**UNITED STATES OF AMERICA
NUCLEAR REGULATORY COMMISSION**

In the Matter of)	
)	
Dominion Virginia Power)	Docket No. 52-017-COL
)	
North Anna Power Station, Unit 3)

**DOMINION VIRGINIA POWER'S
RESPONSES TO PRE-HEARING QUESTIONS**

Figure Q1-1 – Typical Subsurface Profile across Unit 3 Power Block Area
 (FSER Figure 2.5.4-1 Modified to Remove Vertical Exaggeration)

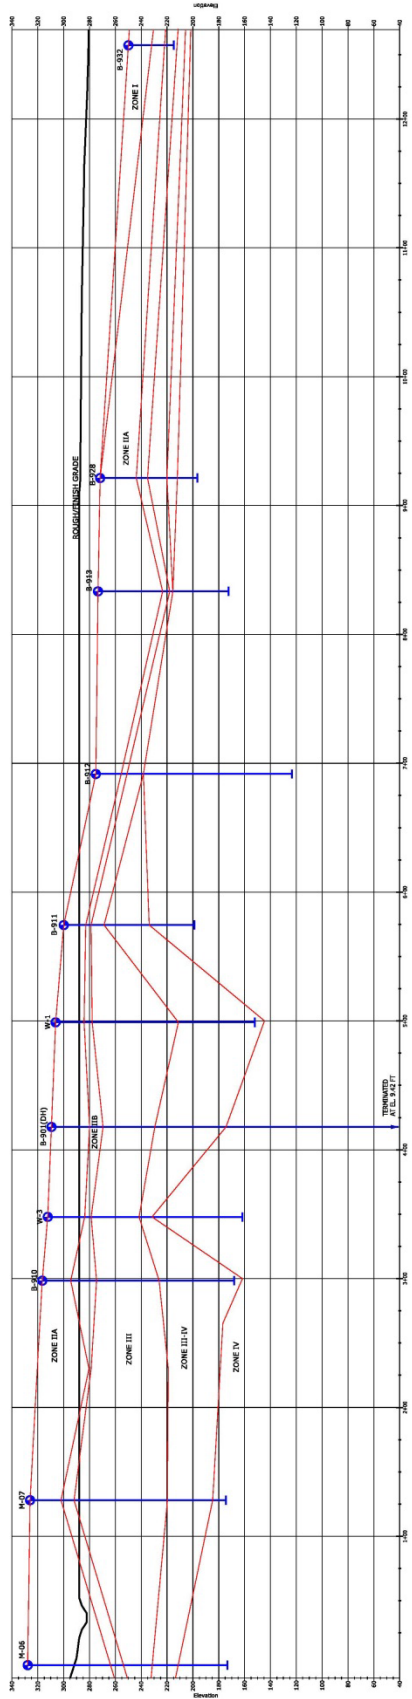
Question 1: In Request for Additional Information 5693, 2.5.2-3a, dated May 5, 2011 (ML11125A124), the Staff asked the Applicant to justify the one-dimensional (1D) site response analysis using only vertically propagating shear waves, given the complex topography of the subsurface layers. On August 25, 2011 (ML11241A058), the Applicant responded that the soil and rocks at the site are all derived from the same parent rock. The Applicant attributed the subsurface variability to the localized effects of weathering on minerals comprising the parent rock rather than to deposition of soil as distinct layers. For lateral variability, the Applicant states that the boundaries between rock types are gradational and so do not represent lateral impedance boundaries that may result in refraction, reflection, or trapping of the shear waves traveling in horizontal directions. Therefore, the site can be characterized as undulating, but not *dipping*, thus justifying the 1D analysis. The Applicant uses the same weathering process to explain the existence of vertical variation, but with distinct boundary impedances at different depths as shown in Final Safety Evaluation Report (FSER) Figure 2.5.2-5. Please discuss why the same weathering mechanism generates sharp boundaries vertically, but not laterally.

Response: The North Anna site is located within the Piedmont Upland Section of the Piedmont Physiographic Province – the topography in the site region is described as gently undulating, with slopes typically ranging from 2 to 5 percent. The bedrock formation immediately below the

The end product of rock weathering depends on the composition of the rock and the weathering processes. The various stages of the weathering in place of the North Anna bedrock can be seen in Figure Q1-1 (FSER Figure 2.5.4-1 modified to remove the vertical scale exaggeration). The sound bedrock (Zone IV) degrades to slightly-to-moderately weathered rock (Zone III-IV), then weathered rock (Zone III), then saprolite (Zones IIA and IIB) which is mainly granular soil that still exhibits the structure of the bedrock, and finally clay soil (Zone I) which contains no relict bedrock structure and is now mostly absent from the site. Because of the vertical progression of the weathering process, these zones are nominally horizontal. Some random lateral variation (as seen in Figure Q1-1) occurs because the weathering processes are not always uniform, and the rock is not entirely homogeneous. It should be noted that the zone separations depicted on the figure are made by joining the zone boundaries in the borings by straight lines for simplification

– in reality these changes will be a gradual transition (similar to the ground surface) and thus the description of “undulating.”

The question references FSER Figure 2.5.2-5 (shear wave velocity (V_s) profiles for the Reactor Building/Fuel Building (RB/FB) and Control Building (CB) used in site response analysis) as depicting the distinct boundary impedances at different depths. As described above, these are boundaries of variation of impedance in the vertical direction (termed “vertical impedance boundaries” here) defined by the approximately horizontal zone boundaries caused by weathering. Because the weathering impact on the rock is severe, the vertical impedance boundaries are significant, as illustrated in FSER Figure 2.5.2-5. The random and relatively small lateral variations as shown on the figure do not produce equivalent lateral impedance boundaries. The vertical impedance boundaries of the V_s profiles in FSER Figure 2.5.2-5 are somewhat simplified for use as input to the site response analysis. The V_s values are averaged over 10 ft intervals, and thus the sharp impedance boundaries in FSER Figure 2.5.2-5 do not reflect the transitions between zones that inevitably occur in a weathering profile. These slight approximations are accounted for in the randomization of the V_s profile as part of the response analysis. Similarly, local variations in the V_s profile due to variations in the weathering patterns are taken into account in the randomization process.

The question notes the reference to the site being characterized as undulating rather than dipping to justify the 1D analysis. In a dipping rock site, layers that are present on one end of the site may be absent on the other end, and vice versa. If these layers have distinctly different dynamic properties (V_s , damping, etc.), then the site response can be quite different at either end of the site – and additional analytical efforts would be needed to reconcile this situation. As described above, this is not the case with the undulations at the North Anna site.
